**NOTICE OF DENIAL**

**RE: Application Number 22-8048; 1515 Chicago; Boston-Edison Historic District  
Project Scope: Erect rear deck, replace front porch columns**

# DHDC 22-8048

### CERTIFICATE OF APPROPRIATENESS

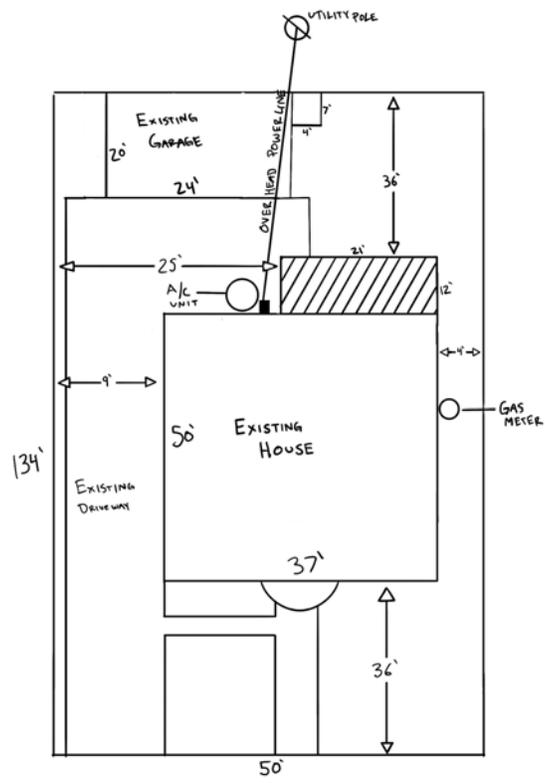
For the columns, I have sent close ups showing the extent of the damage/poor repair of damage to the columns so I don't have anything else to share on that front. But that really isn't the reason we are asking to replace all four. We could repair the three original columns, but then we would still have a fourth column that does not match so it wouldn't really solve the issue in our opinion. From my understanding of the research our assistant did, our first plan was to have a replica of the three original columns made to replace the mismatched fourth column with. Unfortunately she was not able to find a company that made custom designed columns, all of the companies she was able to find only made select styles, none of which were a close enough match to the originals. This is why we asked to replace all four columns to create a matching set of four columns. It is also my understanding that she could not find columns in the exact height of our existing columns in order to save the pedestal boxes. If we were to somehow find columns that allowed us to rebuild the wooden box pedestals, would it help us to get approval for replacing all four? As I mentioned in my previous emails, we are also open to having the fourth column replaced with an exact replica of the original three if we could be provided with a referral to a company that can provide that service, as that would be the easiest and best solution. Let me know if there is anything else I can help with!

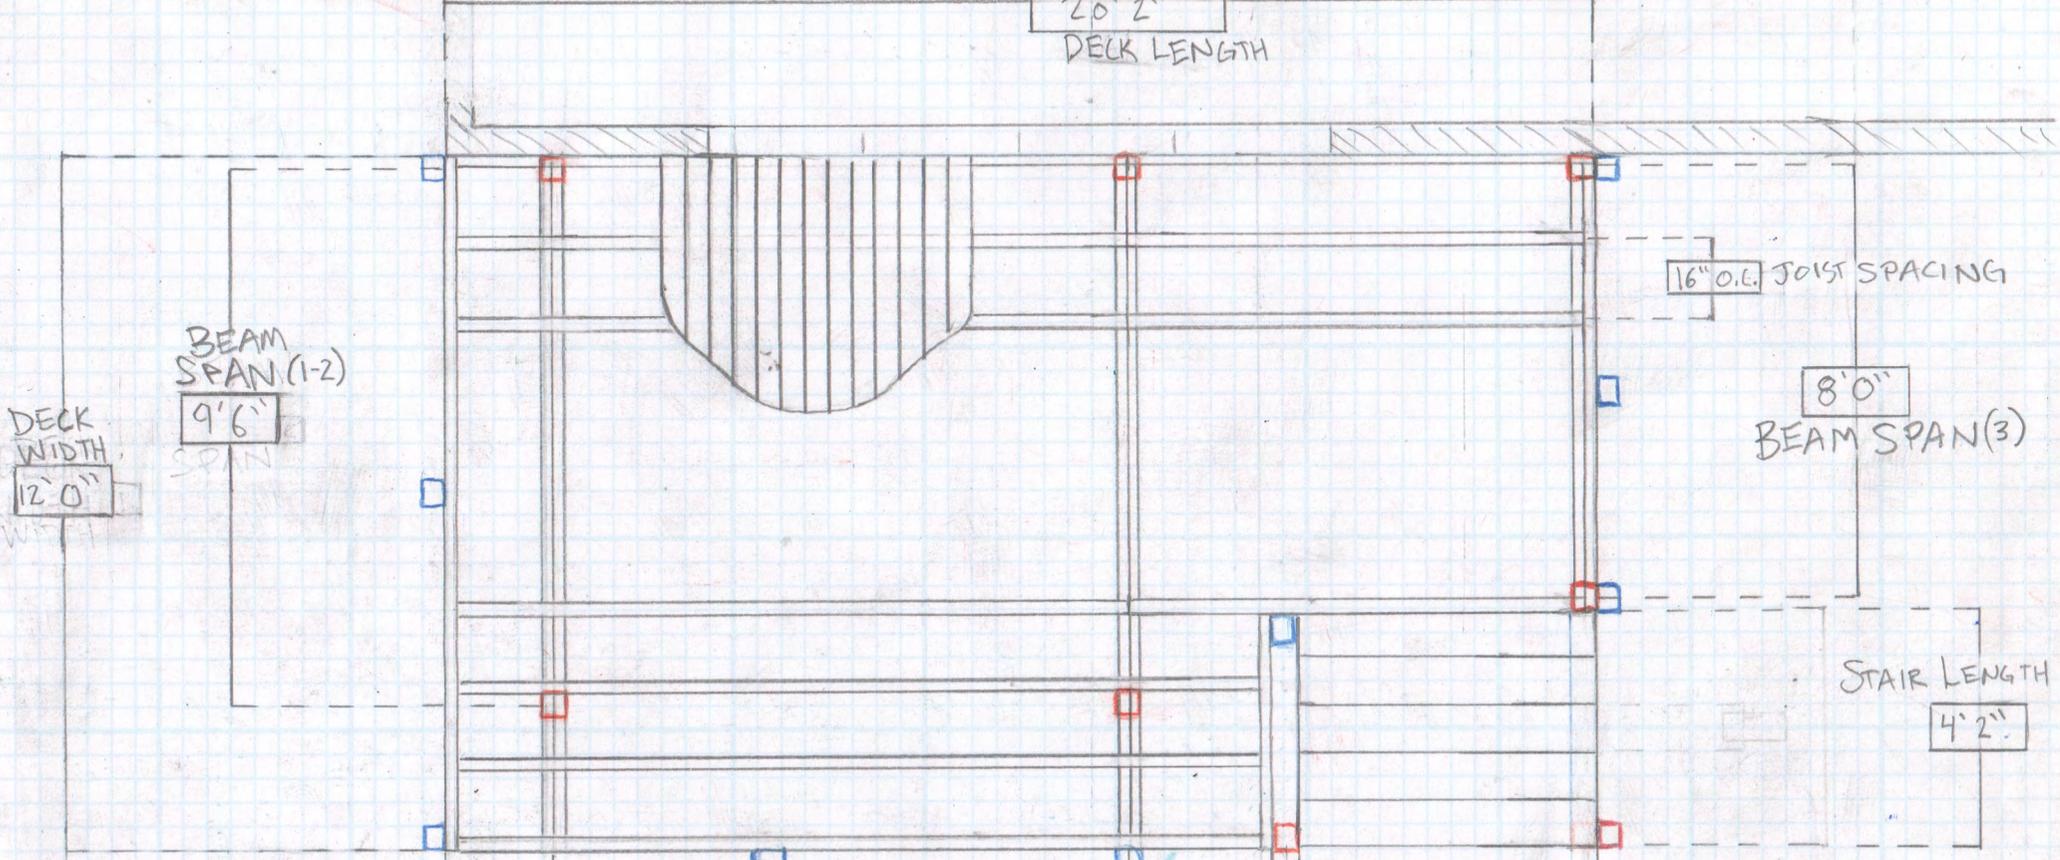
In my deeper review of the house, I noticed work done in the recent past that was not reviewed/approved by the Commission, which includes the painting of the porch floor and steps, porch face brick and column pedestals. These painted elements are a violation. Below left is a 2009 Google image (the 2011 Google image shows the porch elements painted) and the 1974 designation photo more clearly shows the original materials' finishes. I would like to know if you want to add these violations to the application, asking that they remain as-is, or if the property owner would like to remedy the unapproved work, as this would affect your current scope of work. Also, do you have a more

I was unaware of the changes that were made to the porch, they must have been made by the previous owner after the 2011 photo you sent me. I guess I would ask to allow us to keep that part of violated repairs to the porch as is because I do not think we would be able to remove that concrete without damaging the bricks underneath. If that were the case, we would be open to painting the porch the same color brown that is on it now, or we could also try to power wash back down to the concrete finish first if they would rather us try that? We would also like to keep the column and roof portion of the porch the same almond color that is on it now, from the looks of the 2010 photo I believe it was already switched to that color by a previous owner as well.
